RE: **Approval of Site Plan # 18-018654**– Carver Auto Sales Paving Project for the auto sales area at 1328 Point Douglas Rd. – Site Plans prepared by Loucks Associates with revisions through 07/03/2018.

Site Plan Review Report

SPR File # 18-018654

Project: Carver Auto Sales

GRADING PLAN
C3-1

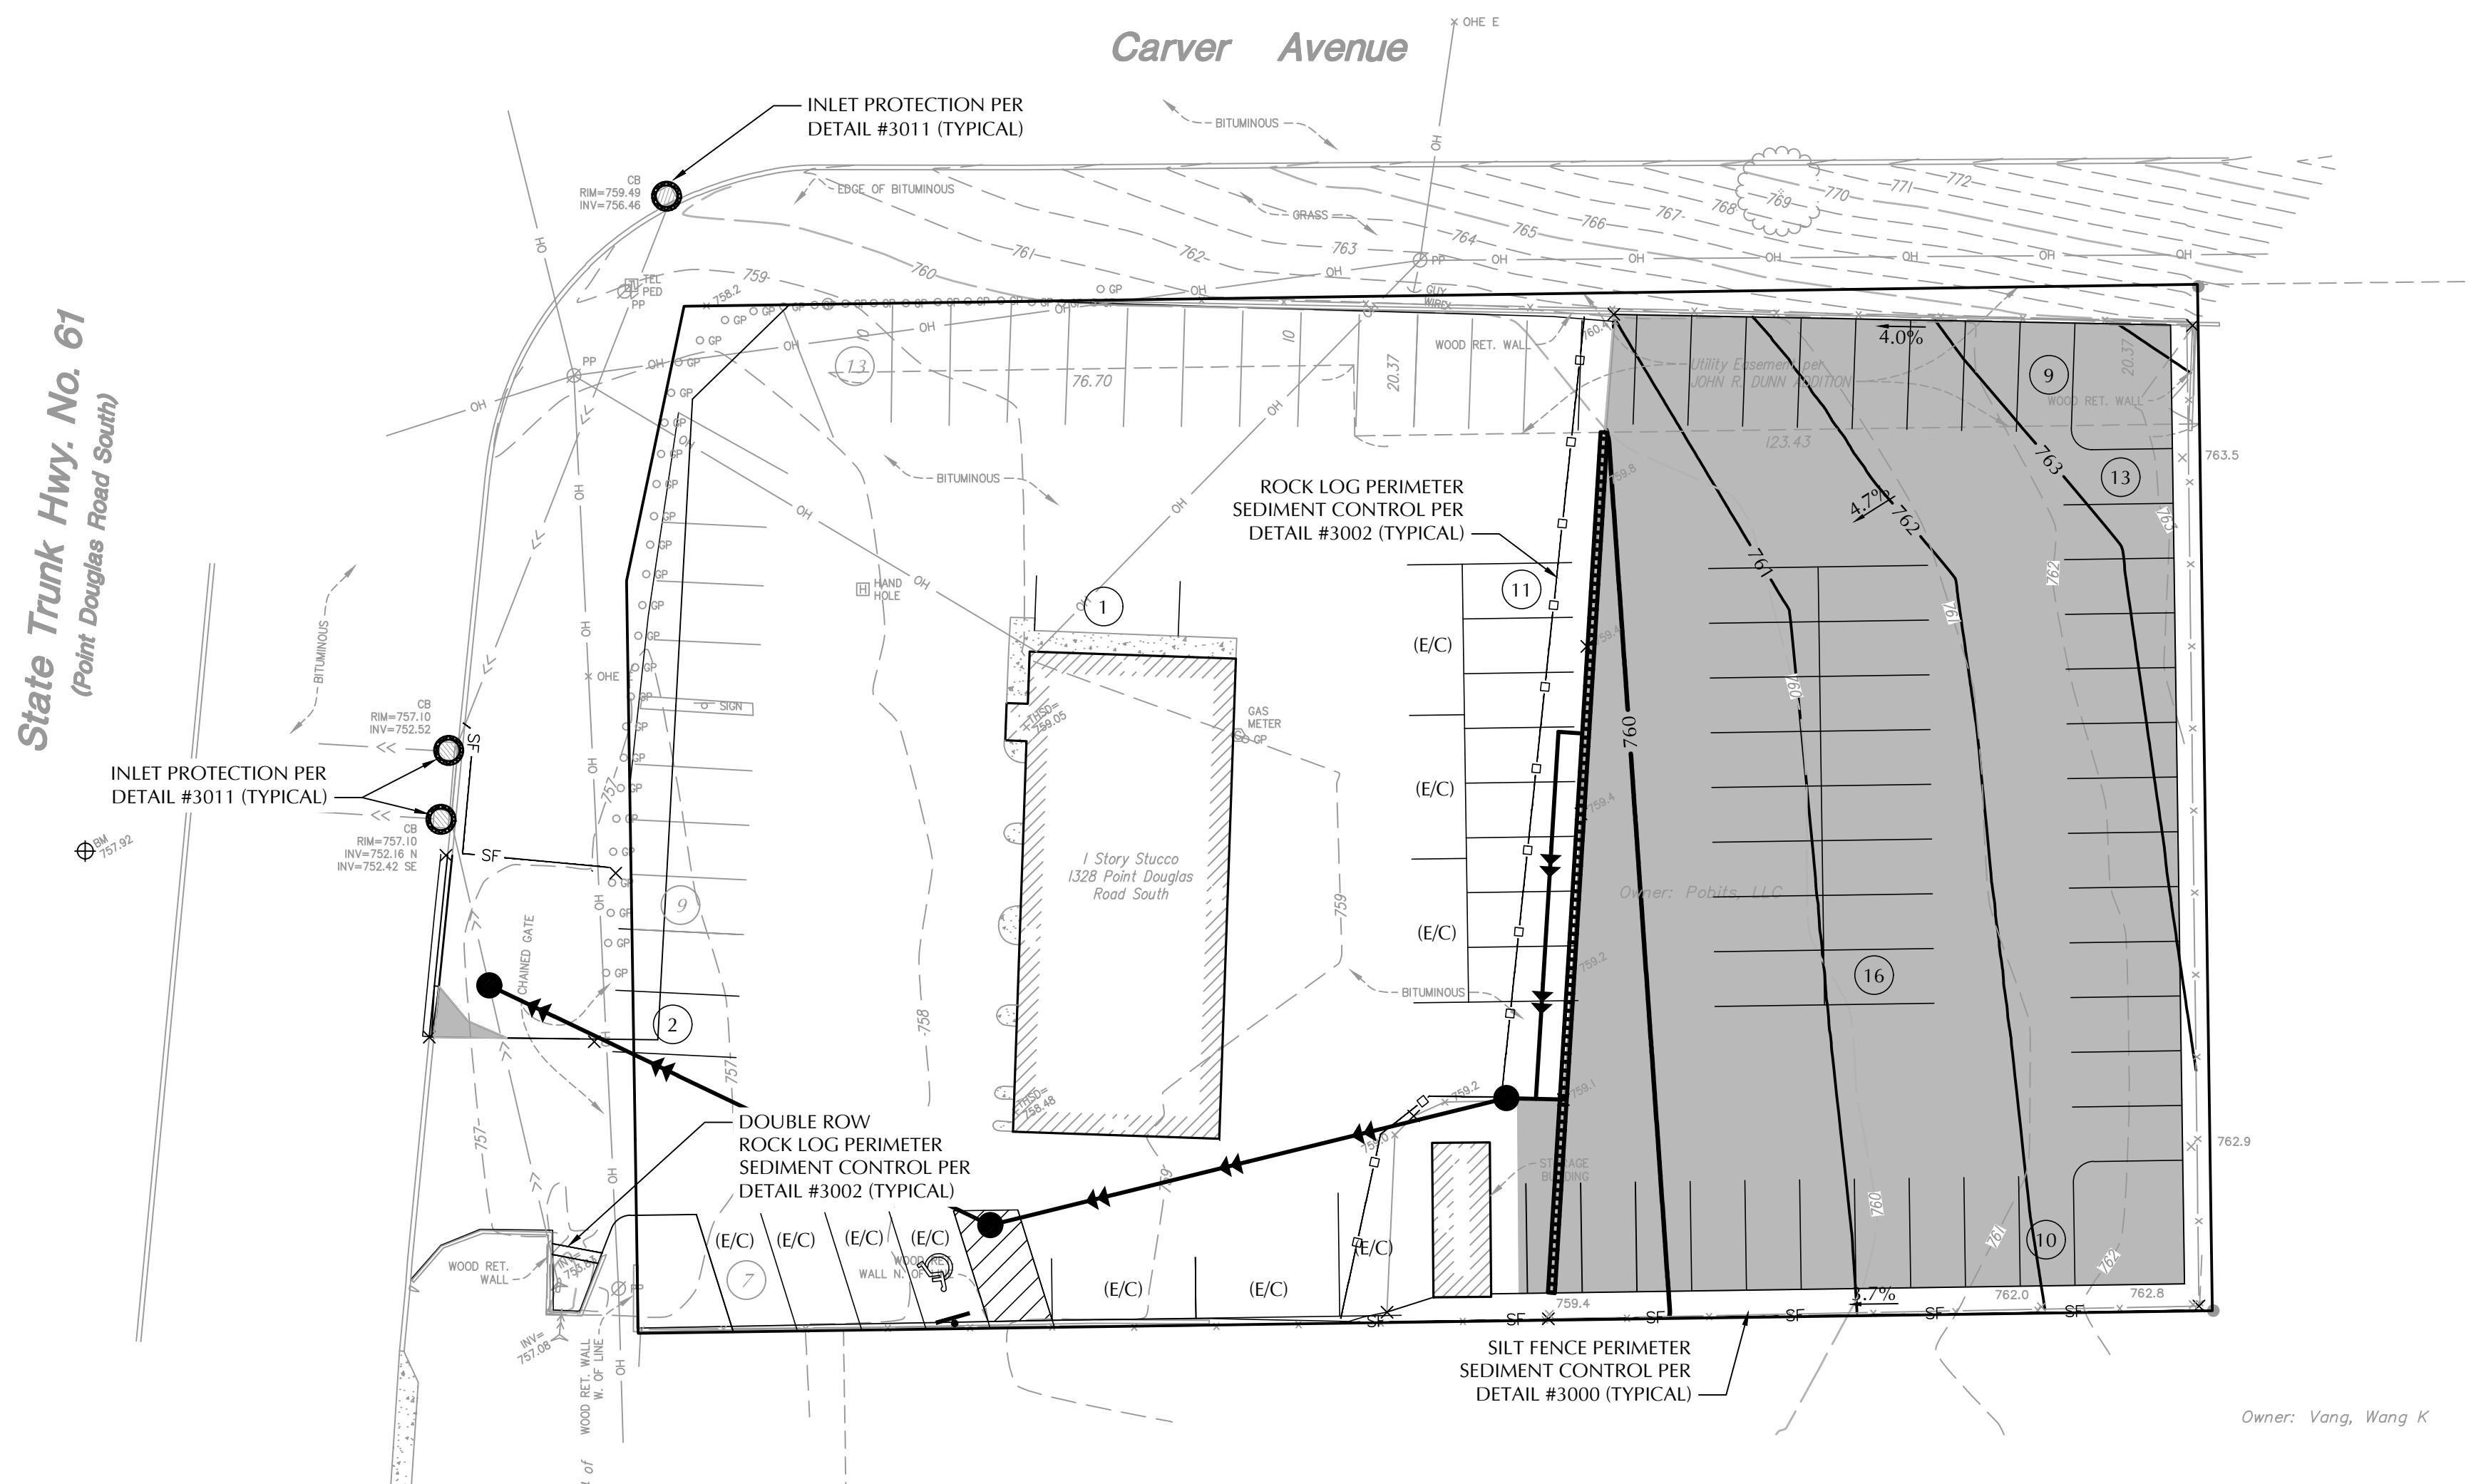
Provide the following on PLAN SHEET C3.1 under NOTES:

- Maintain 8 feet of cover over all water mains and services.
- All water service valve boxes within construction area must be exposed and brought to grade upon completion of construction.
